Groundwater Application Review Summary Form

Application # G- 19422

PUBLIC INTEREST REVIEW FOR GROUNDWATER APPLICATIONS

TO: Water Rights Section Date 12/17/2024
 FROM: Groundwater Section Travis Brown
 Reviewer's Name
 SUBJECT: Application G- 19422 Supersedes review of _____
 Date of Review(s)

Well Interference Analysis (Theis, 1935)Parameters for All AnalysesTransmissivity: T1 = 70 ft²/day | T2 = 800 ft²/day | T3 = 1,600 ft²/day [Pumping Test Reports]

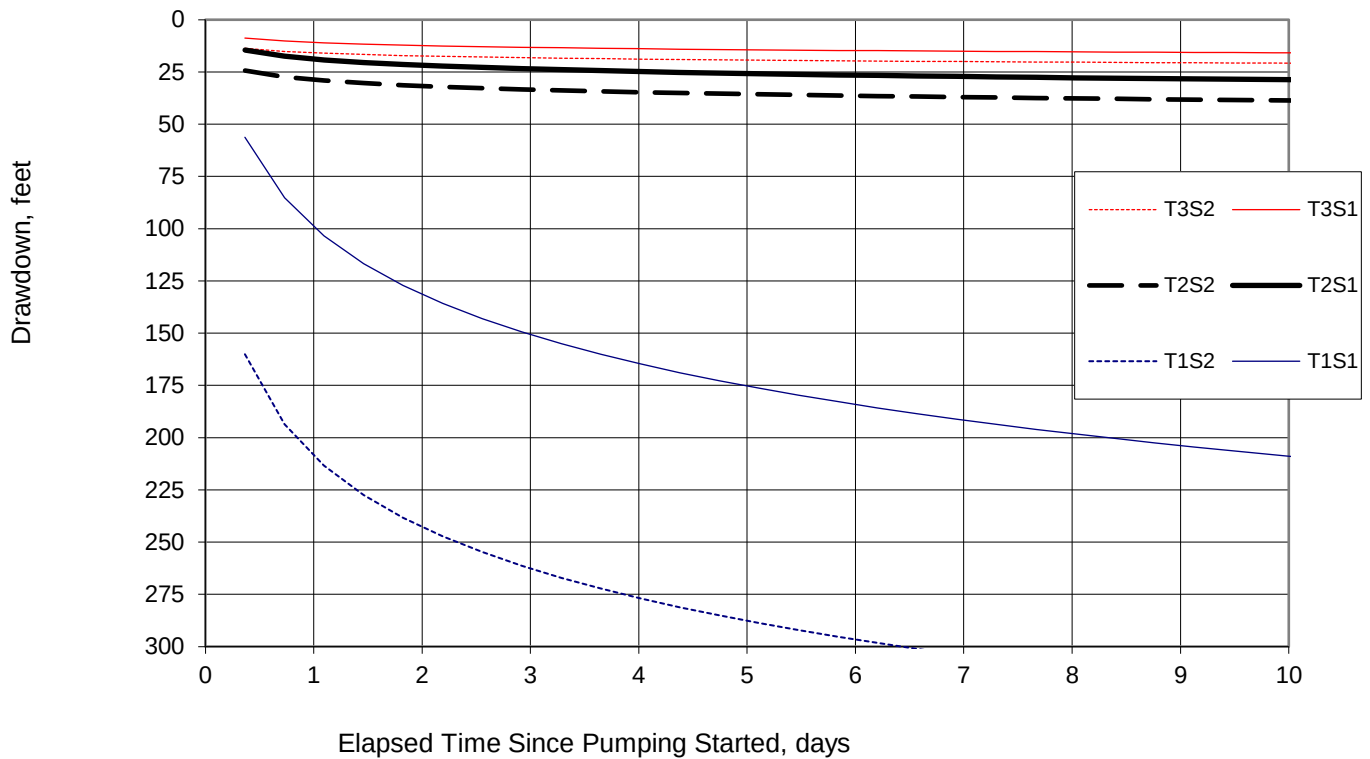
The nearest neighboring well to the proposed POA is presumed to be CLAC 9983, ~150 north of proposed Well 2. The potential interference with CLAC 9983 from Well 2 was analyzed using the Theis (1935) solution for drawdown in a confined aquifer (see attached Well Interference Analysis). Results of the analysis indicate that, within 1 week of continuous pumping at the maximum requested rate of 0.5 cfs, interference with CLAC 9983 from the proposed use would likely exceed 25 ft – the limit for acute hydraulic interference under the standard permit conditions for new groundwater rights. Once the permit condition limit is exceeded, the proposed use would need to be curtailed, meaning the proposed use could not operate at the requested rate. **Therefore, the proposed use is beyond the capacity of the groundwater resource.** At a rate of 0.206 cfs, sufficient to exhaust the full duty (100 af) within 245 days (the standard irrigation season – not the requested season of use), the 25 ft limit on hydraulic interference would not likely be exceeded; **if the application were amended to lower the requested rate for proposed POA Well 2 to 0.206 cfs or less, the proposed use would then be within the capacity of the resource and a technical re-review would not be necessary to confirm this finding.**

Well 1 to CLAC 2208

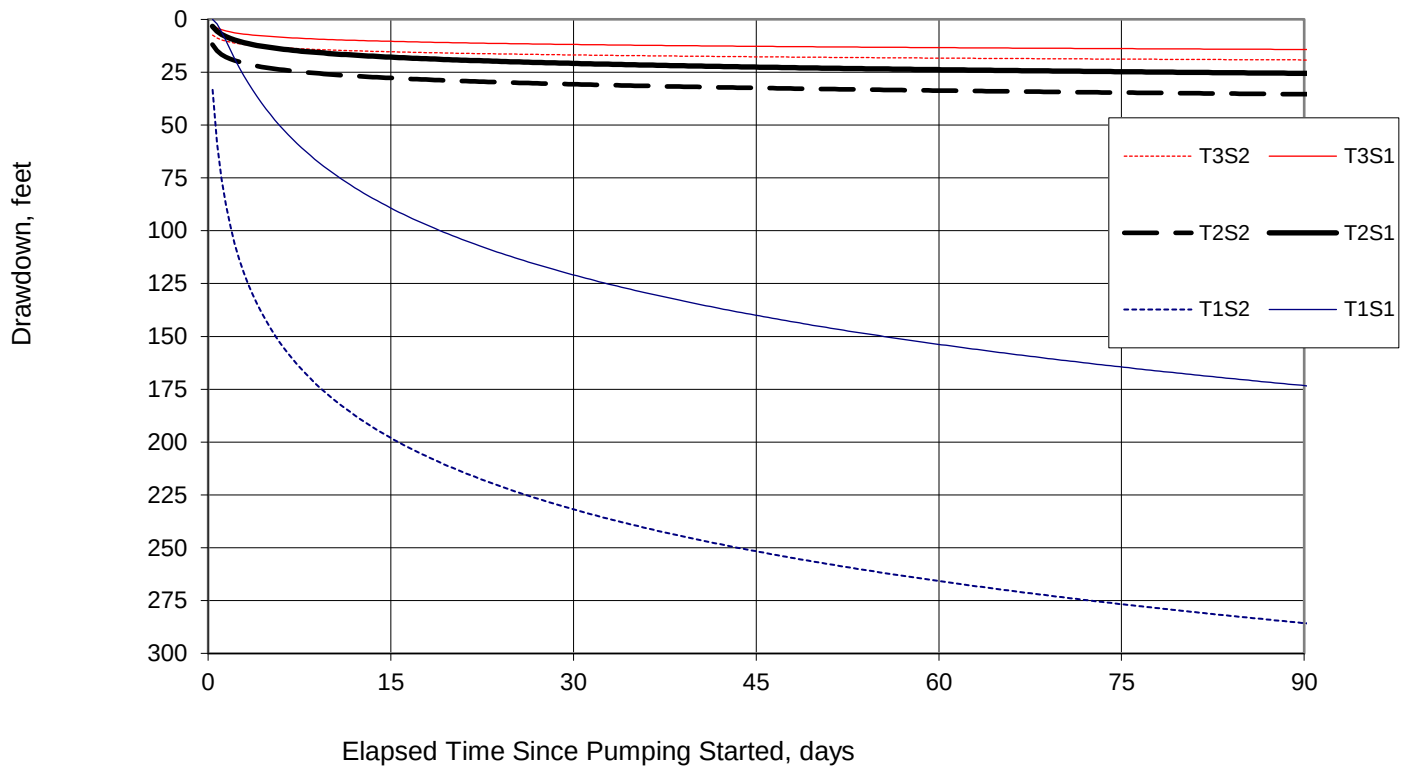
The next nearest neighboring well is presumed to be CLAC 2208, ~550 ft southwest of proposed Well 1 (CLAC 54578/60358). The potential interference with CLAC 2208 from Well 1 was analyzed using the Theis (1935) solution for drawdown in a confined aquifer (see attached Well Interference Analysis). Results of the analysis indicate that, within 10 days of continuous pumping at the maximum combined rate of 0.72 cfs (under both this application and Certificate 85578), interference with CLAC 2208 from the proposed use would likely exceed 25 ft – the limit for acute hydraulic interference under the standard permit conditions for new groundwater rights. Once the permit condition limit is exceeded, the proposed use would need to be curtailed, meaning the proposed use could not operate at the requested rate. **Therefore, the proposed use is beyond the capacity of the groundwater resource.** At a rate of 0.35 cfs (0.22 cfs from Certificate 85578 plus 0.13 cfs from this application), the 25 ft limit on hydraulic interference would not likely be exceeded; **if the application were**

amended to lower the requested rate on this application for proposed POA Well 1 to 0.13 cfs or less, the proposed use would then be within the capacity of the resource and a technical re-review would not be necessary to confirm this finding.
